Indian Point Nuclear Generating Unit No. 3

Stretch Power Uprate
License Amendment Request Package

Re: Indian Point Unit No. 3
Docket No. 50-286
NL-04-069

SUBJECT: **Proposed Changes to Technical Specifications:
Stretch Power Uprate (4.85%) and Adoption of TSTF-339**

Figure 2.1-1
Rated Power (Percent of 3067.4 MWt)
100 PERCENT RATED POWER IS EQUIVALENT TO 3067.4 MWt
Pressures and temperatures do not include allowance for instrument error

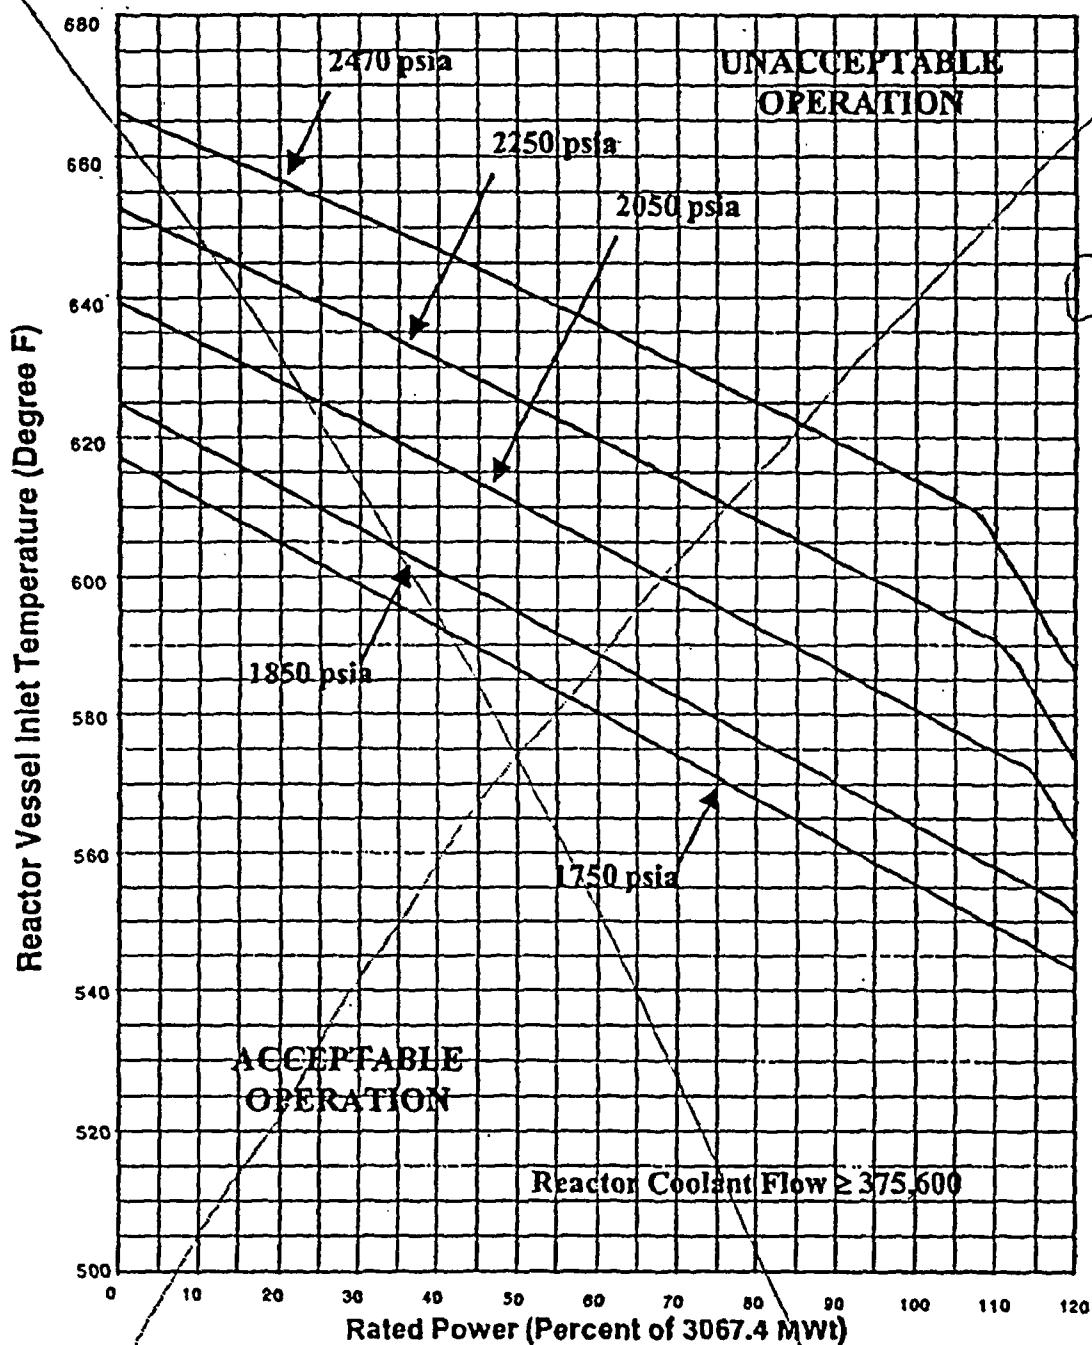
- Relocating updated Figure 2.1-1 (Reactor Core Safety Limits) to the COLR,
- Adding new requirements 2.1.1.1 and 2.1.1.2 for DNB and peak fuel centerline temperature limits, respectively; and
- Related Bases changes as specified in TSTF-339.

The Reactor Core Safety Limits curve has been updated to reflect the proposed stretch uprate conditions. This new curve, being relocated to the COLR, is shown in Figure 6.3-1, Section 6.3 of WCAP-16212-P, provided in Attachment III.
